**AUDIT REPORT
OF
“NORTHERN EAST-WEST HIGHWAY PROJECT”
IMPLEMENTED BY
REGIONAL OFFICE, LOBEYSA,
DEPARTMENT OF ROADS, MINISTRY OF WORKS AND HUMAN
SETTLEMENT**

RAA/AR/ DSA-SCID/RO-Lobeysa/2019/1384

Dated: 29th May 2019

Subject: Audit Report of GOI funded project "Northern East west Highway Project" (NEWH) implemented by the Regional Office, Lobeysa for the period from inception to 30.6.2017

Fig: 2.1 –Initial approved design and drawings

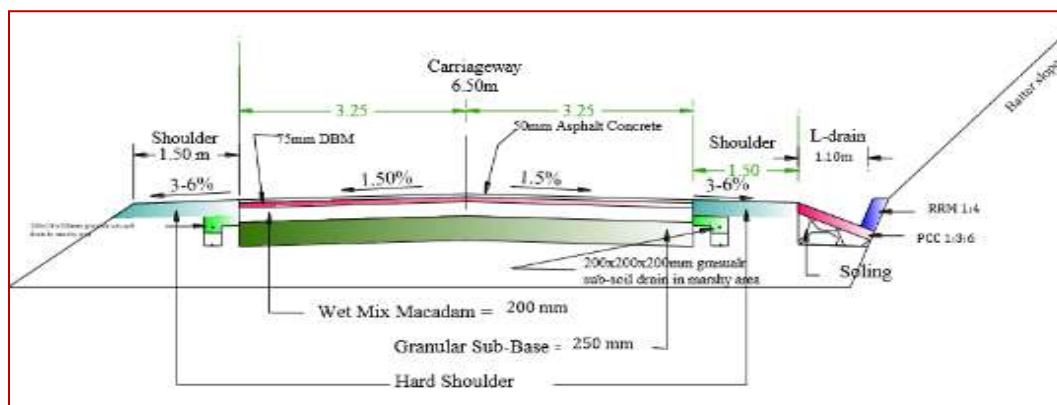
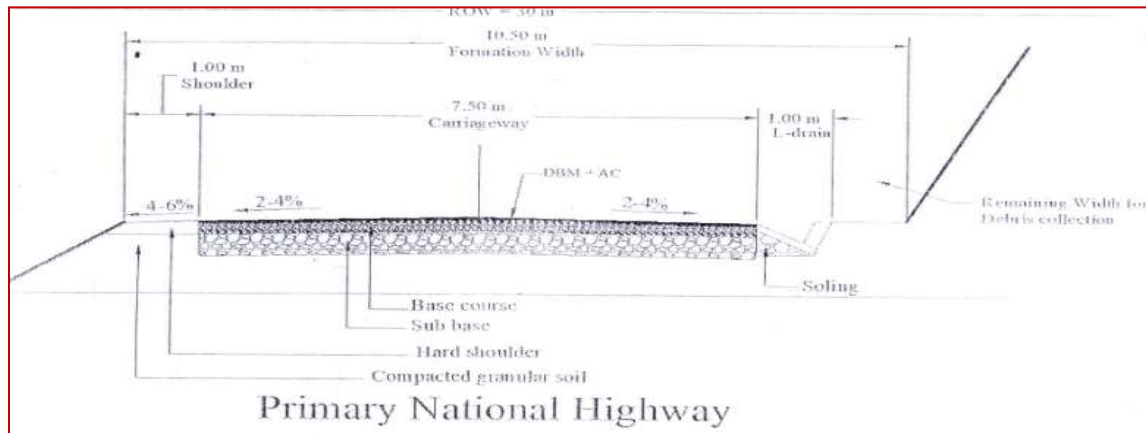
However, vide letter No. MoWHS/Sec-29/2015-2016/524 dated 16th October 2015, the Secretary, MoWHS had conveyed the meeting held on **16th June 2015** with the contractors and directed the Regional Offices for issuance of amendment to the contract agreements based on the decisions subsequently taken to increase the carriageway width from 6.5m to 7.5 m. Reasons for increase of carriageway width was found not documented.

In addition, vide letter No. DoR/ROL/16/15-16/481 dated 21/10/15, all Regional Offices were informed to increase the pavement width from 6.5 meters to 7.5 meters. In line with change order,

Thus, the increase of pavement width of 1m from the initial carriageway width of 6.5m to 7.5m after a time lapse of almost eight months from the dates of awards of contract works was irrational and inappropriate as it had not only distorted the drawings, estimates, BOQs, Projected Cost and funding modality but also adversely impacted the overall project cost by **Nu. 317,636,875.54** as summarized in table 2.1 below:

The Regional Offices in consultation with the Ministry should comment on the changes of drawings and technical specifications after the awards of contract works that had resulted in additional avoidable financial implication to the extent of **Nu. 317,636,875.54**.

*In addition, the extra financial burden to the government due to change is design and technical specification particularly due to increase of 1m carriage way alone after the contract awards amounted to Nu. 317.637 million (**Ministerial Level Committee were responsible for the changes**)*

The Ministry should not only strengthen the Design Divisions for accurate designing of road structures but also institute a technical team to review project plans, designs, and

Figure 1.5(2): Revised drawing No. 1: Pavement drawing followed by RO Lobeysa and Lingmethang

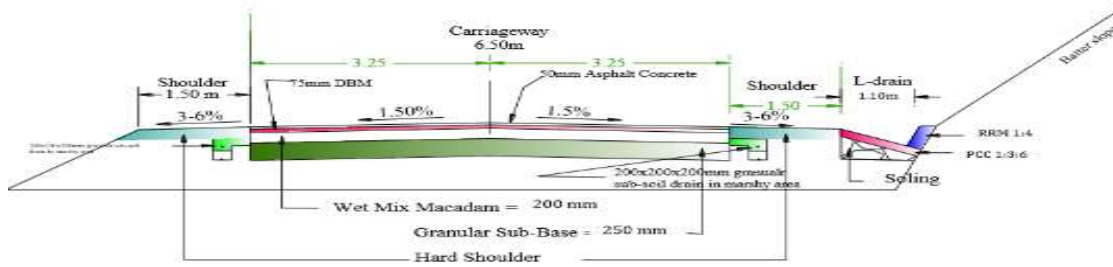
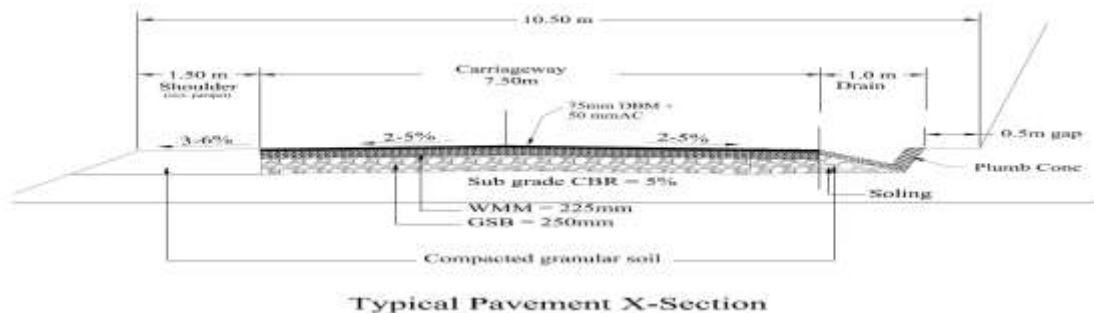
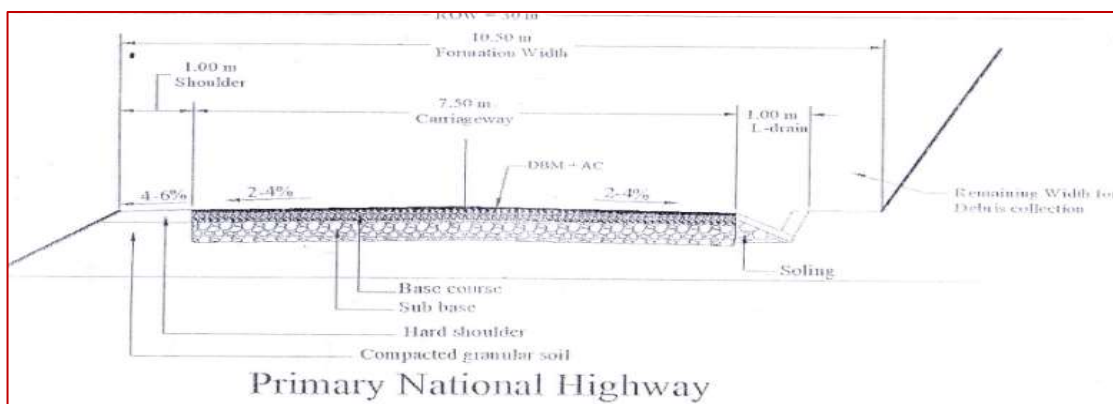
It was noted that RO Thimphu and Trongsa were following one drawing and RO Lobeysa and Lingmethang were following a different as shown in Figure 1 & 2 below:

Thus, for the Primary National Highway, two different types of pavement drawings and specification were applied resulting in inconsistency in the implementation of Double Lanning works as well as non-adherence to the Road Design Standards specified in the *Guidelines on Road Classification System and Delineation of Construction and Maintenance Responsibilities 2009*.

Adoption of two different drawings with varying pavement specifications and non-adherence to the approved Road Design Standard indicated improper planning and lack of due diligence in the preparation of drawings and specifications. Such mismatches in technical specification of road works would inevitably result in execution of two different type of pavement works for the same NEWHdouble lanning works.

The ministry should review the circumstances leading to the implementation of two different sets of designs by the ROs besides instituting design review process to ensure consistent and uniform implementation of designs and drawing for similar projects in future.

In addition, the Ministry should also revisit the revised designs circulated to ROs, as the requisite gap between hillside and drains was found not maintained in majority of the work due to site specific and alignment problem of the drain works. Further, the Ministry should also relook on

Fig: 2.6(2)- Revised design and drawing

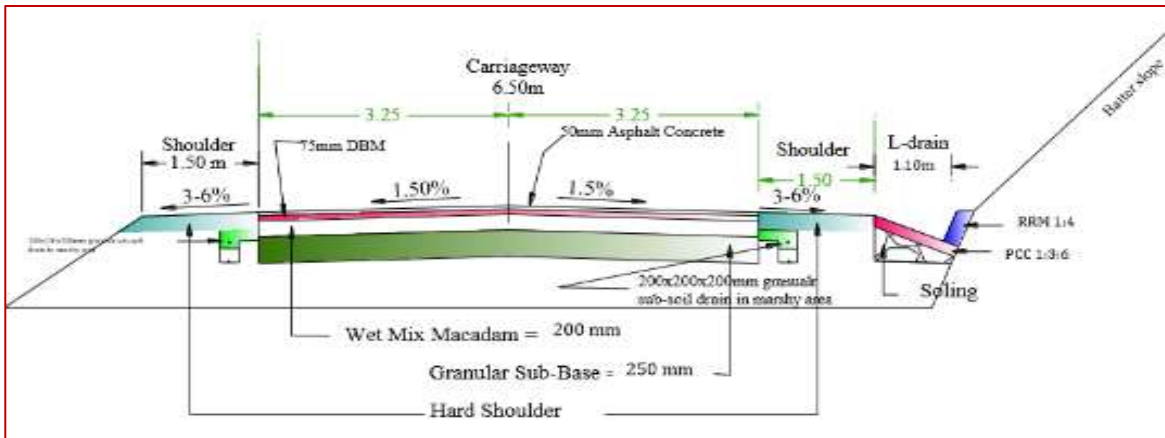
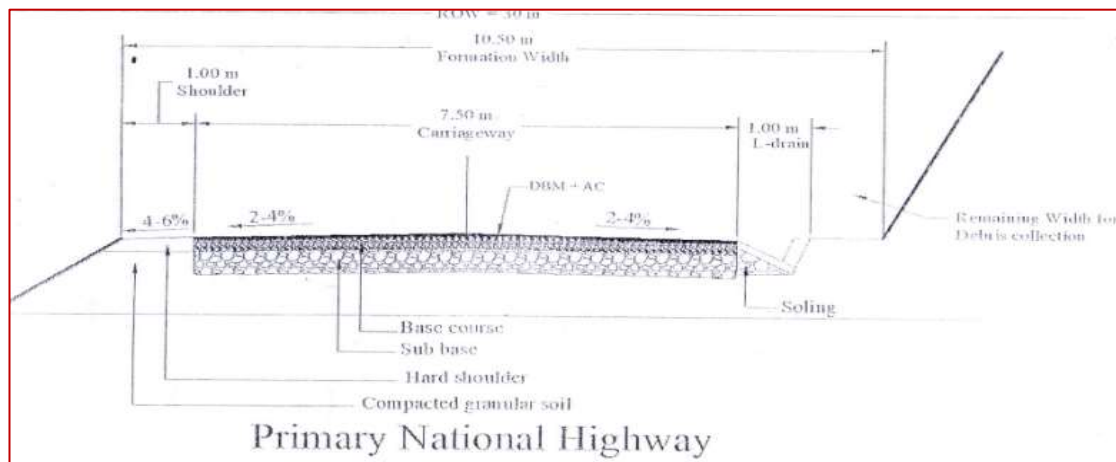
While the subsequent design and drawing had maintained increased carriage pavement width of 7.5m, other structural drawings were also changed from the initial designs and drawings as evident from the above photograph.

The above changes in the design and drawing not only resulted in extra financial implication to the government exchequer for increase of 1m carriage width to the extent of approximately Nu.317.637 million but also impeded timely completion of work due to grant of time extension for the increased scope of work as well as compromised safety measures by doing away Hard shoulders of 1.5m width between the L-Drain and Paved carriageway width including reduction of 0.5m hard shoulder at valley side. Besides, due to design changes, overall formation width of 10.5m were found not achieved as 1m width supposedly maintained for Debris collections between hillside and L-Drain were found not maintained in entirety for all stretches of the roads as majority of the L-Drain was found constructed attached to the hillside. Further, 1m shoulder width on the valley sides were also found not maintained as in some stretches of roads the pavement road were found executed at the edge of the road width.

In this connection, the Ministry may also comment on the following aspects:

As discussed in the exit meeting, the DOR in consultation with the Ministry should revisit the revised drawing for appropriate decisions and taking measures to address any technical flaws and ambiguities. Besides, the Ministry should also look in to the requirement of approval of Cabinet on the revised designs as it had deviated from “The Guidelines on Road Classification System and Delineation of Construction and Maintenance Responsibilities 2009”.

Fig: 2.1(1)-Revised design and drawing

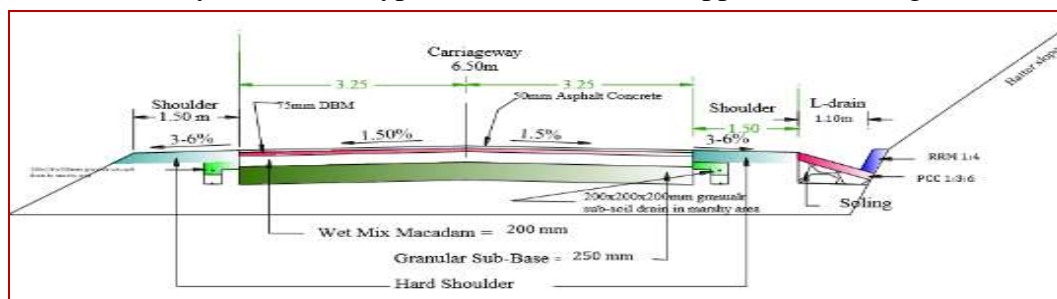
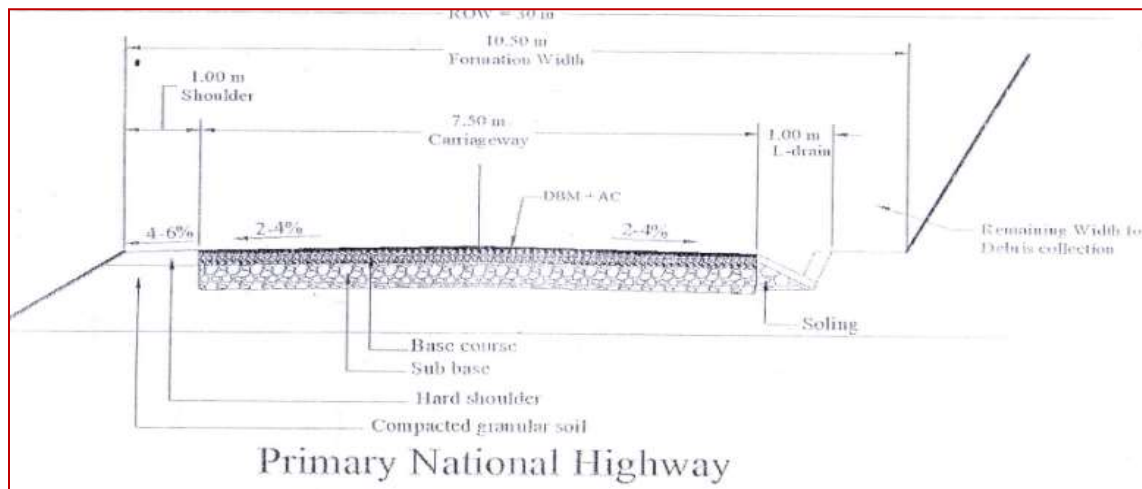
Initial drawing with the bidding documents has provisioned for Carriageway of 6.5 mtrs, 1mtr L-drain and hard shoulder of 1.5mtrs each on both side of road with granular sub soil drain to be provided in marshy areas. The typical cross section of approved drawing which was issued in

Thus, in line with the revised drawing, the pavement works were to be carried out to increase the carriage way width to 7.50m from 6.5 meters.

The detail analysis of road width is shown in the picture below:

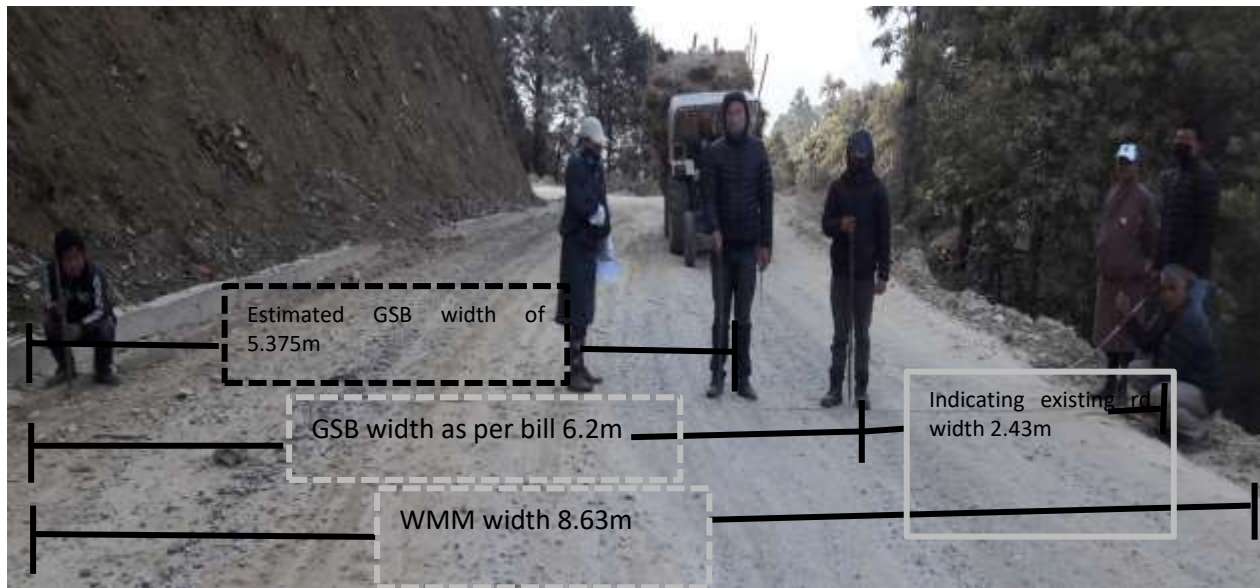
Further, in terms of the MB and RA bills, the average width of GSB provided on widened road were calculated to 6.31m and WMM paved road width of 8.39m thereby showing the existing road width as just 2.08m (8.39m minus 6.31m). In terms of the carriageway of 7.50m, the existing road width works out to just 1.19m (7.50m less 6.31m) indicating flaws in the measurement of executed works recorded in the MB and RA bills.

Considering the flaws in the width of existing road, the audit team along with DoR officials physically measured the existing road width at Khelekha where widening work was not carried out. The physical verification/measurements of existing road indicated the average existing road width of 4.23m (***Refer to joint physical measurement sheet on existing road width***).

The analysis of road width is as shown in the photograph below:

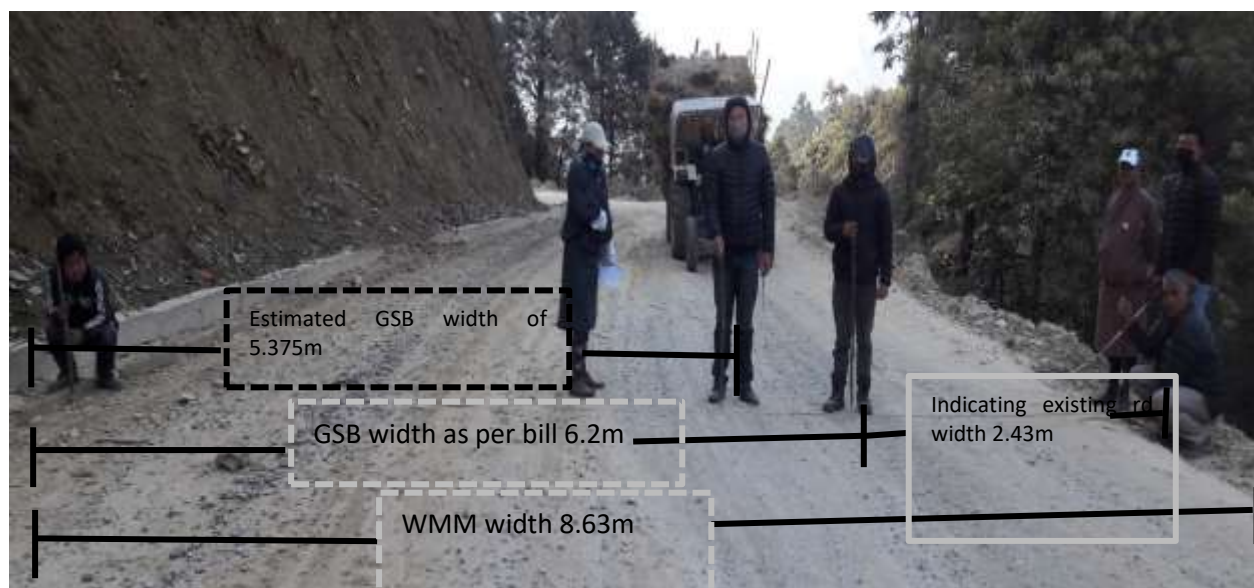
Further, in terms of the MB and RA bills, the average width of GSB provided on widened road calculated to 6.2m and WMM paved road width of 8.63m thereby showing the existing road width as 2.43m (8.63m less 6.2m). In terms of the carriageway of 7.50m the existing road width works out to just 1.30m (7.50m less 6.2m) indicating flaws in the estimates and executed works recorded in the MB and RA bills.

Considering the flaws in the width of existing road, the audit team along with DoR officials physically measured the existing road width at Khelekha where widening had not been carried out. The physical verification/measurements of existing road revealed average existing road width of 4.23m (**Refer to joint physical measurement sheet on existing road width**).

Fig:12: Approved drawing for French drain

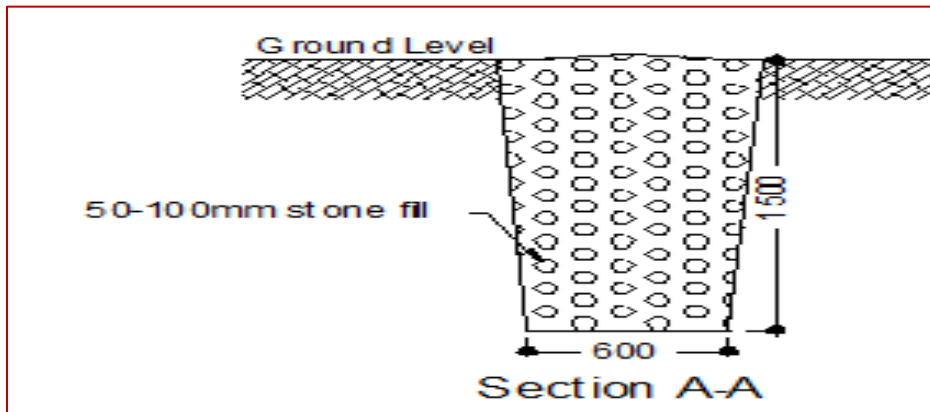
Standard drawing for the French drain showed 50-100mm stone fill instead of GSB as per detail cross section of the French drain as depicted in the drawing below:

In contrary to the drawing and the specification, the contractor was paid for execution of GSB and sub grade preparation valuing Nu.464,605.66 which was beyond the scope of work. The details of work done and payments made are shown in table 12.1 under:

Fig:e 18.1: Mesh wires tornoff

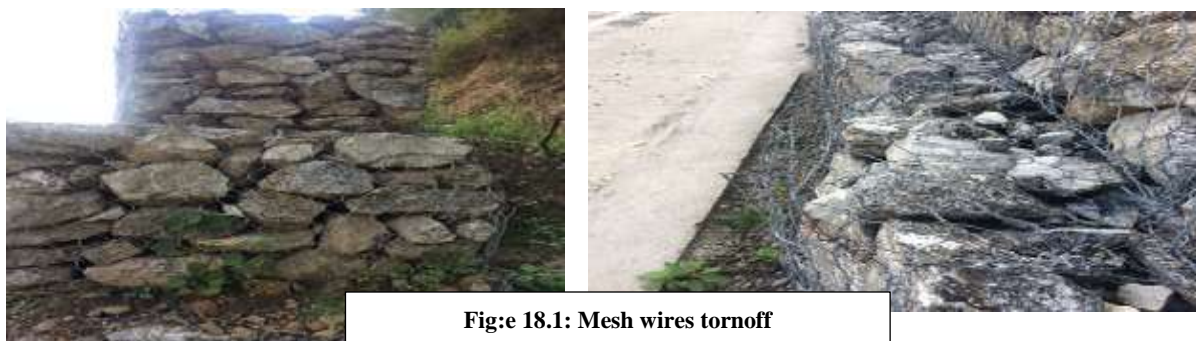
During the physical verification of executed works, it was observed that the weaving of GI mesh, fixing of selvedge wire, binging/lacing and execution of gabion works were of poor quality and workmanship. The RAA noted development of huge voids, gabion crates and bulged out, binding wire rusted and stone used were of river boulders which did not comply with the technical specifications.

In addition, GI wires was found to be of inferior quality as the mesh were found rusted indicating that the material were not galvanized resulting in lower durability. Un-galvanized wire is vulnerable to weather and rusting. Photographs below depict use of low quality wire mesh and poor workmanship:

The execution of poor works indicates lack of proper monitoring and taking over of defective works by the Taking over Committee. The RO, besides justifying the execution of poor quality works should make the contractor to re-do the defective works in line with approved technical drawings and workmanship. The rectification carried out should be furnished to RAA for verifications.
